UNITED STATES PATENT AND TRADEMARK OFFICE

APPLICATION NO.	FILING DATE	FIRST NAMED INVENTOR	ATTORNEY DOCKET NO.	CONFIRMATION NO.
10/777,016	02/11/2004	Joe Karkosch	502336	2227
53609	7590	09/26/2005		
REINHART BOERNER VAN DEUREN LTD. 483 NORTH MULFORD ROAD SUITE 7 ROCKFORD, IL 61107			EXAMINER SELF, SHELLEY M	
			ART UNIT	PAPER NUMBER
			3725

Office Action Summary	Application No. 10/777,016	Applicant(s) KARKOSCH ET AL.	
	Examiner Shelley Self	Art Unit 3725

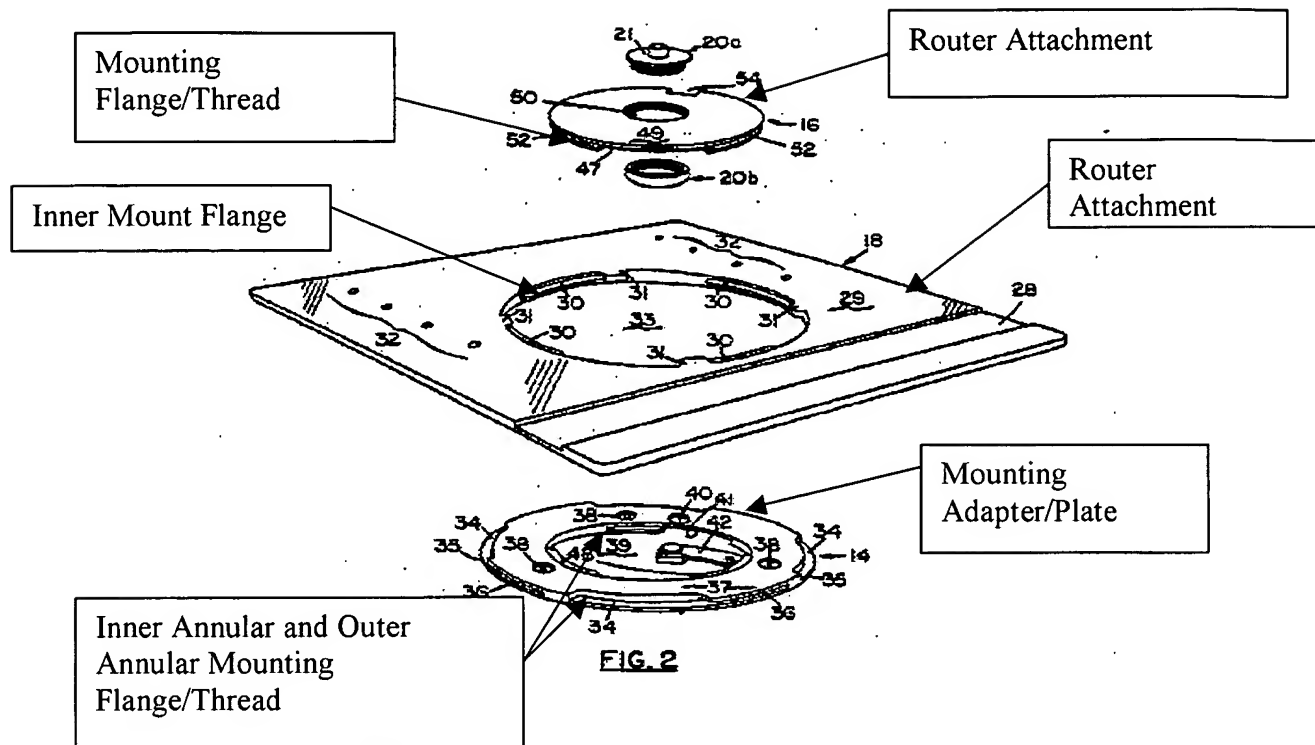
Examiner notes that the router attachment and mounting adapter are manually vertically rotatable relative to each other so as vertically lock and release the mating structure of the mounting adapter (14) to that of the router attachment (16, 18).

Further Examiner notes that the mounting adapter has two annular mounting surfaces (i.e., an inner mounting surfaces and on outer/radial mounting surface) of which two router attachments (16, 18) are able to be attached/mounted to the corresponding mounting adapter mounting surfaces.

With regard to claim 2 as best as can be understood, Hedrick discloses the lock comprises corresponding snaps (30, 31, 36) on the attachment and mounting surface (fig. 2), the snaps snapping past each other during rotation from the release position to the attached position to hold the router attachment (18) in the attached position (col. 10, lines 28-33).

With regard to claim 7 as best as can be understood, Hedrick discloses the mounting adapter (14) includes first flanges (fig. 2) projecting radially along the annular mounting surface, and wherein the attachment housing includes second flanges (fig. 2) projection radially along the annular attachment surface, the first and second flanges being vertically movable past each other in the release position to permit vertical removal of the router attachment from the mounting adapter, the first and second flanges interlocking with each other when in the attach position to prevent vertical removal.
